HOPE CREEK GENERATING STATION  
DOCKET NO. 50-354  
FSAR COMMITMENT STATUS THROUGH AUGUST 1984

ATTACHMENT I  
HOPE CREEK GENERATING STATION  
FSAR COMMITMENT STATUS THROUGH AUGUST 1984

QUESTION 220.21 (SECTION 3.7.2)

220.21-37

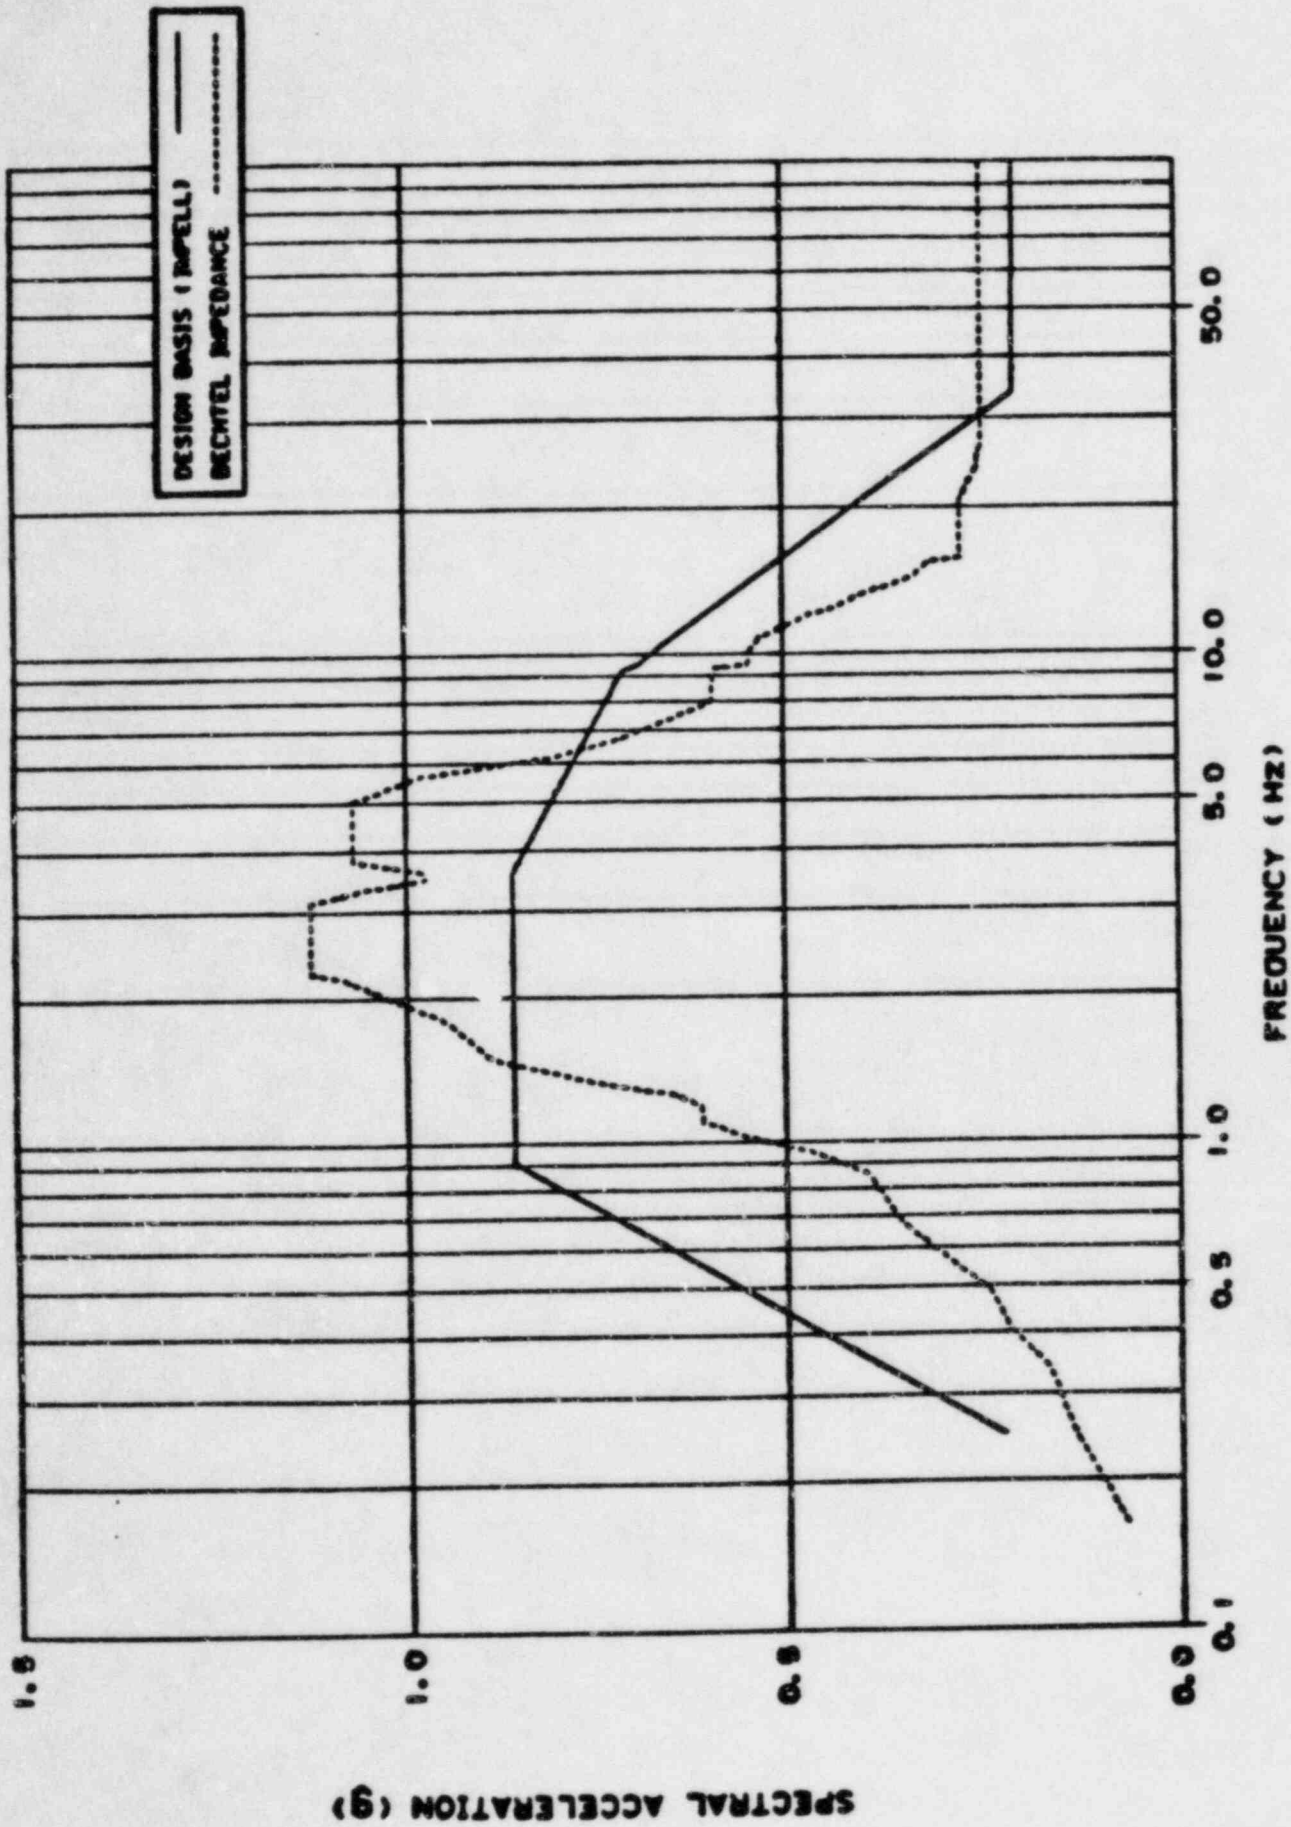
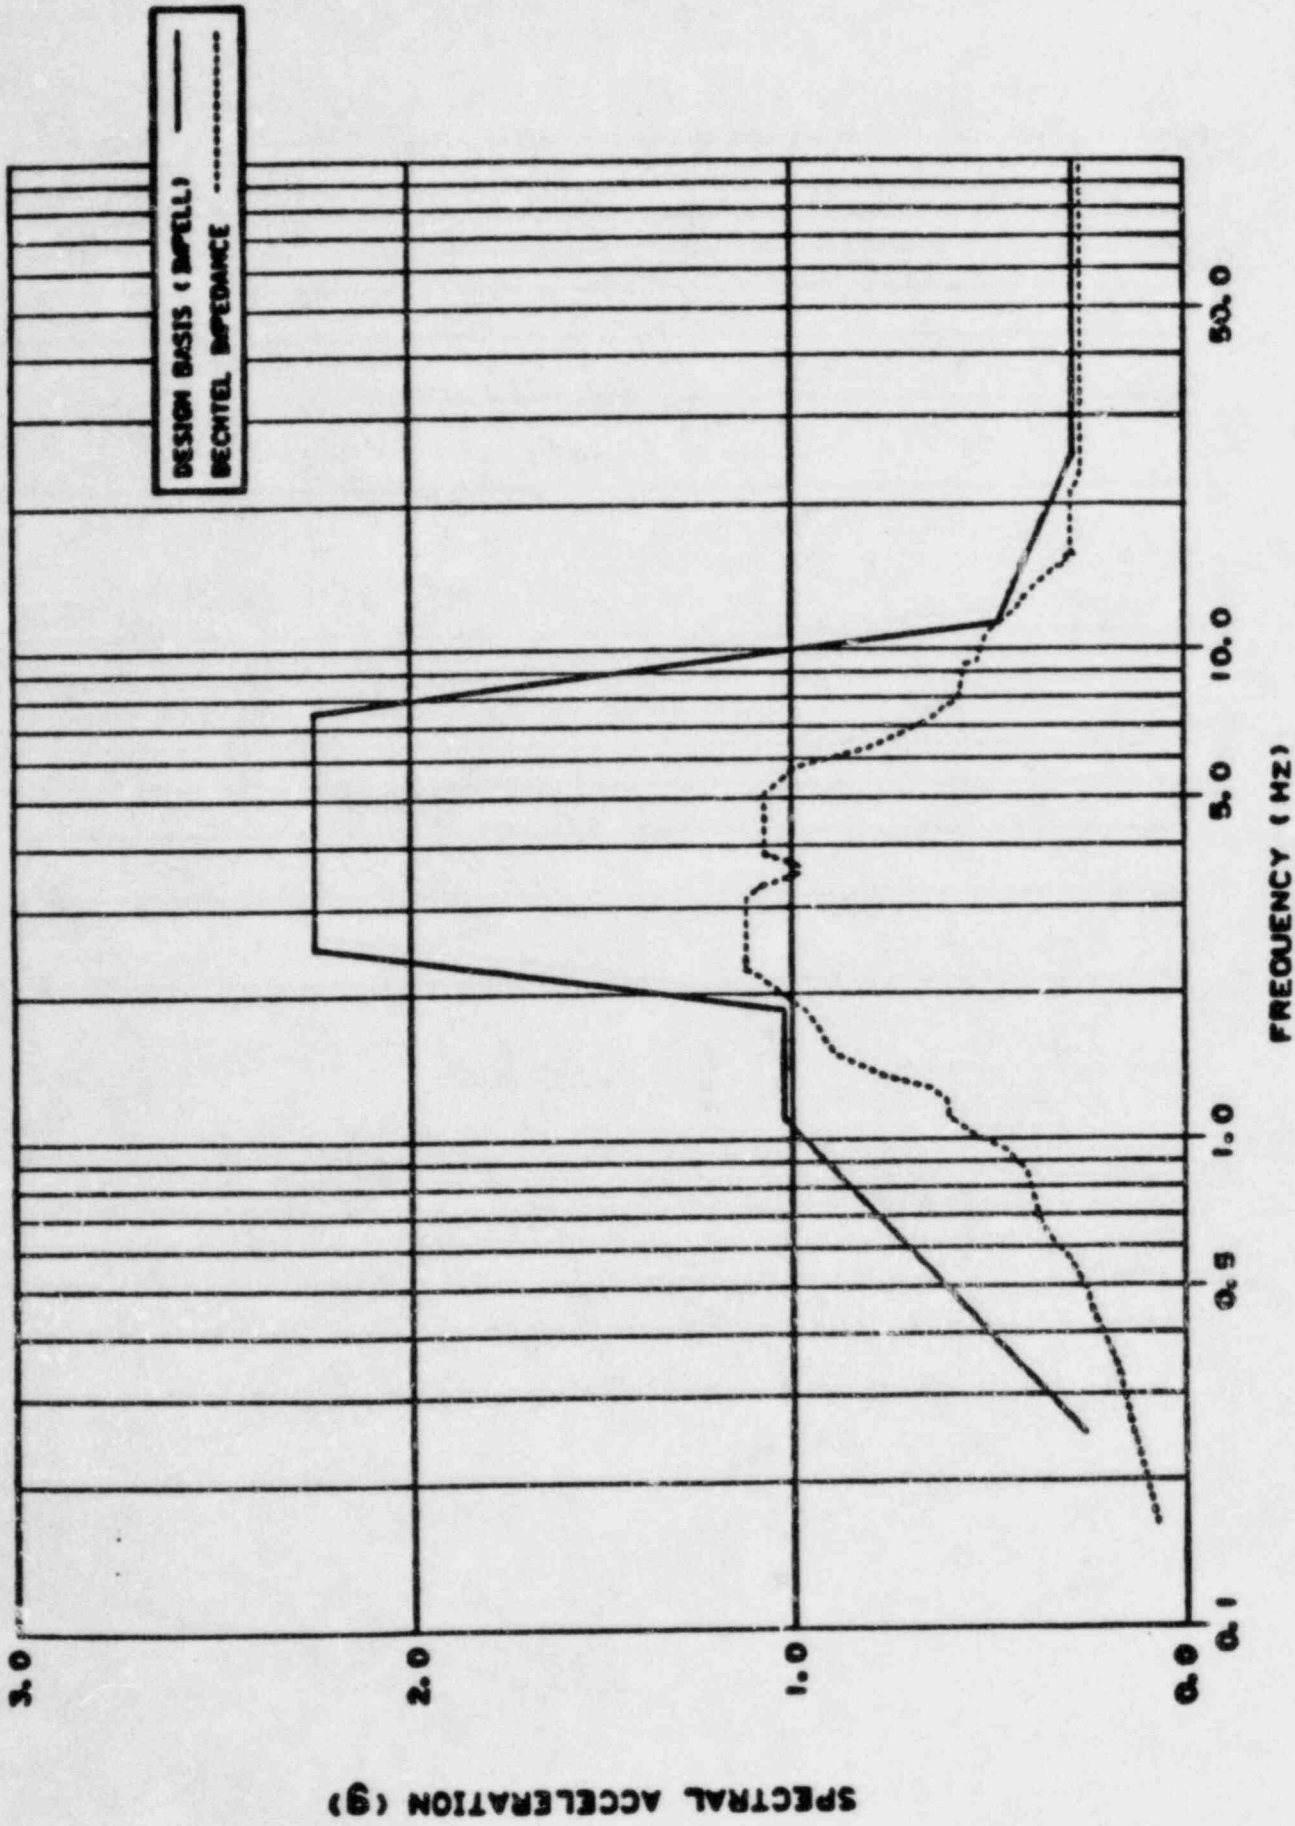
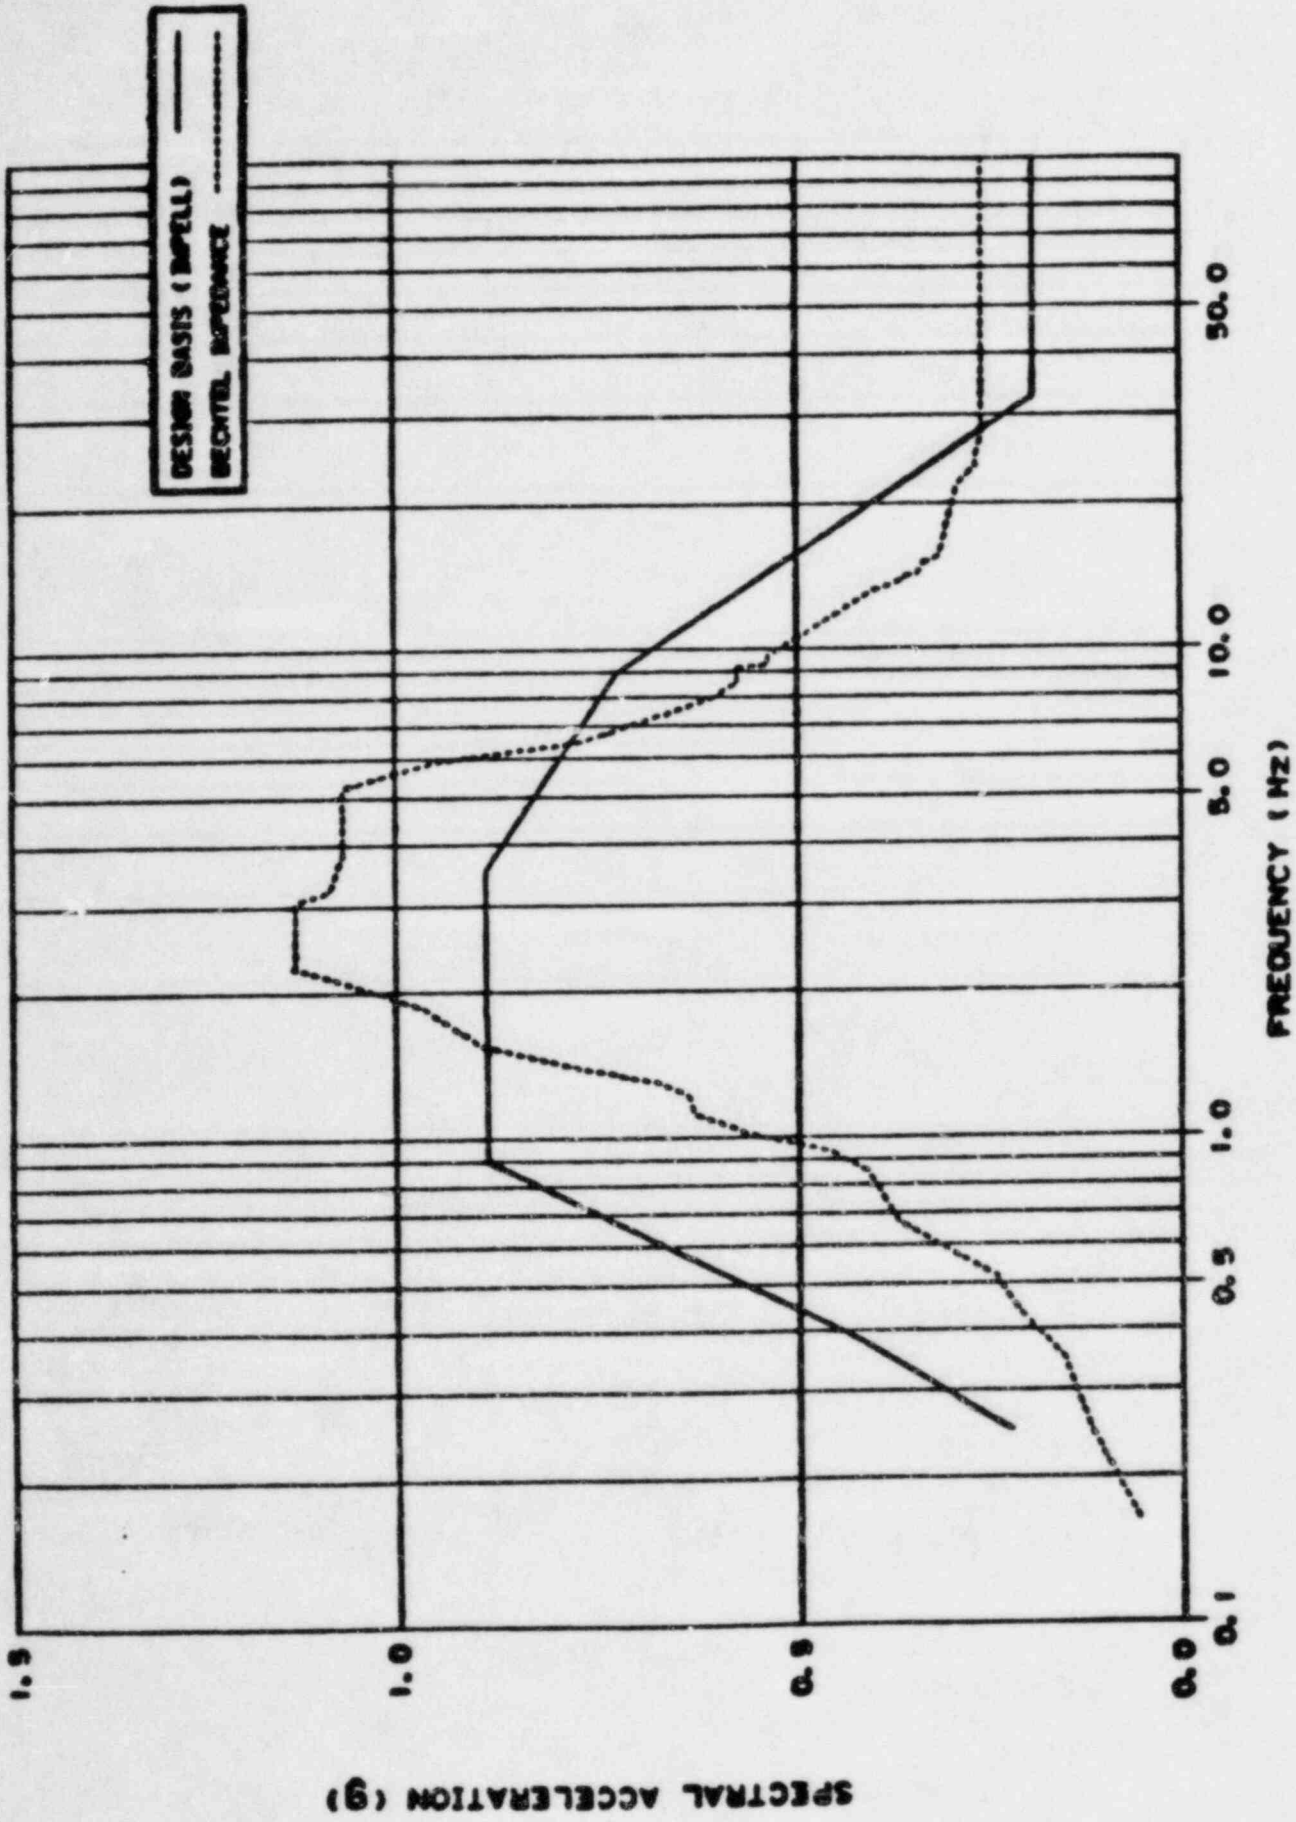
The Hope Creek soil-structure interaction analysis is performed by applying a specified earthquake input motion at the base of the finite-element model. The base level input motion is generated through a deconvolution analysis. The applicable SRP criteria for soil-structure interaction analysis require that both the half-space and finite-element approaches should be considered. (For details refer to SRP 3.7.2-11.4). Public Service should perform necessary analyses to demonstrate conformance to the criteria.

Figures 220.21-1 through 220.21-54 show a comparison of the 2 percent damping response spectra obtained from the design basis finite element and the impedance analyses for the reactor building, auxiliary building and the service water intake structure (SWIS).

¶ For the reactor and auxiliary buildings, the peak spectral accelerations obtained from the impedance analysis are generally lower than those obtained from the design basis analysis. However, the impedance analysis response spectra are not completely enveloped by those obtained from the design basis analysis, especially in the frequency range from 1.0 to 3.5 Hz. Also, there are some local exceedances in the higher frequency range, as shown in Figures 220.21-1 through 220.21-36. ¶ For the SWIS (Figures 220.21-37 through 220.21-54), the impedance analysis response spectra are generally enveloped by those obtained from the design basis analysis at elevation 114.0 feet. For other elevations, the impedance analysis spectral accelerations exceed the design basis spectral accelerations in some frequency ranges. These ranges vary approximately between 1.5 and 10.0 Hz.

forces and moments obtained from the impedance analysis exceeded the design basis values at various locations within these buildings. The auxiliary building seismic shear forces and moments obtained from the impedance analysis are less than the design basis shears and moments.

Since the impedance analysis results are not completely enveloped by the design basis finite element analysis results, sampling studies are conducted to confirm the adequacy of the plant design. These sampling studies include an evaluation of the following items:

In all cases, the items reviewed during these sampling studies can accommodate the loads resulting from the impedance analysis. Therefore, the impedance analysis results have no impact on the plant design.
